Stage 1 (Feasibility) Road Safety Audit Report

Parcels R1/R2, South Marston
Section 38 Highway Works
(Designer and Auditor Responses)

Produced for:
Bloor Homes

Date: 13th February 2026

13. Appendix B - Identified Road Safety Audit Matters Location Plans

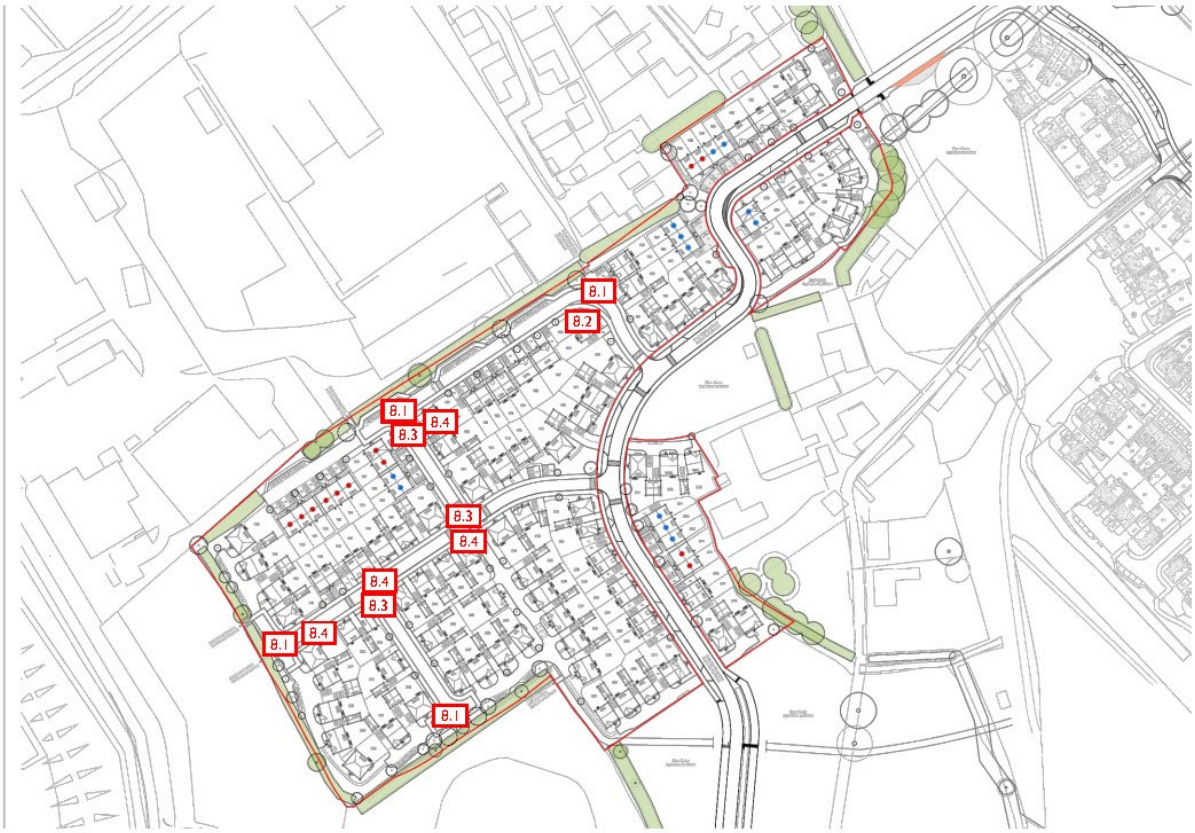
8.1*Problem* (Item A1.12)	
Location:	General
Summary:	Larger vehicles may have difficult negotiating the site
There are a number of locations throughout the proposals where larger vehicles such as refuse vehicles may have difficulty manoeuvring; junction, turning heads and sharp horizontal alignment changes. This may result in kerb strike / loss of control or vehicles having to perform onerous reversing manoeuvres. Carry out swept path analysis of all likely large vehicles that will travel through the site. Amend the design where necessary.	
TYPE OF CONFLICT/COLLISION	
Risk of collisions.	
RECOMMENDATION	
Carry out swept path analysis of all likely large vehicles that will travel through the site. Amend the design where necessary.

8.2*Problem* (Item A3.1)	
Location:	Carriageway alignment at Plots 168/169
Summary:	No forward visibility splays detailed at sharp bend in road alignment
There is a sharp bend detailed adjacent to Plots 168/169. Forward visibility has not been detailed at this bend. A lack of forward visibility may result in head-on collisions at the bend. Check forward visibility splays around bends, ensure they fall over land to be offered for adoption where visibility can be maintained and meet current criteria. Amend design where required.	
TYPE OF CONFLICT/COLLISION	
Risk of head-on collisions due to reduced visibility.	
RECOMMENDATION	
Check forward visibility splays around bends, ensure they fall over land to be offered for adoption where visibility can be maintained and meet current criteria. Amend design where required.

8.3*Problem* (Item A3.2)	
Location:	Proposed junctions
Summary:	No visibility splays detailed
There are a number of junctions to be provided within the parcels. Visibility splays have not been detailed at these junctions. A lack of suitable visibility may result in vehicles emerging from side roads into the path of oncoming vehicles, resulting in collisions. Appropriate junction visibility splays need to be detailed at all junctions to ensure that they are provided free of obstructions and within land to be offered for adoption.	
TYPE OF CONFLICT/COLLISION	
Risk of collisions due to reduced visibility at junctions.	
RECOMMENDATION	
Appropriate junction visibility splays need to be detailed at all junctions to ensure that they are provided free of obstructions and within land to be offered for adoption.

8.4*Problem* (Item A4.2)	
Location:	Proposed pedestrian crossing points
Summary:	No visibility splays detailed at the new pedestrian crossing points
There are a number of pedestrian crossing points detailed throughout the site. There are no visibility splays detailed at these crossing points. Pedestrians need to see and be seen by approaching drivers before crossing the road. Appropriate pedestrian visibility splays need to be detailed at all pedestrian crossing points to ensure that they are provided free of obstructions and within land to be offered for adoption.	
TYPE OF CONFLICT/COLLISION	
Risk of collisions due to reduced visibility at crossing point.	
RECOMMENDATION	
Appropriate pedestrian visibility splays need to be detailed at all pedestrian crossing points to ensure that they are provided free of obstructions and within land to be offered for adoption.

8.1	Larger vehicles may have difficult negotiating the site	Refuse swept path analysis is demonstrated on drawing: SW192-EN-401A which demonstrates the refuse vehicle can manoeuvre around the development without conflict

8.2	Forward visibility not detailed	Forward visibility splays are demonstrated on drawing SW192-EN-401A – Engineering Layout, all visibility splats are contained within the proposed adoptable extents.

8.3	Visibility splays not detailed	Junction visibility splays are demonstrated on drawings SW192-EN-401A – Engineering Layout, all visibility splays are contained within the proposed adoptable extents.

8.4	Pedestrian visibility splays not detailed	Pedestrian crossing points are location at the Junction tangent point in order to reduce the distance at which a pedestrian needs to be on the carriageway, the exact location of the tactile crossings will be determined at the detailed design stage.

8.1 Noted . Local Authority to agree that these meet their standard requirement
8.2 Agreed
8.3 Agreed
8.4 Agreed. Ensure all ped vis splays detailed are over adopted land
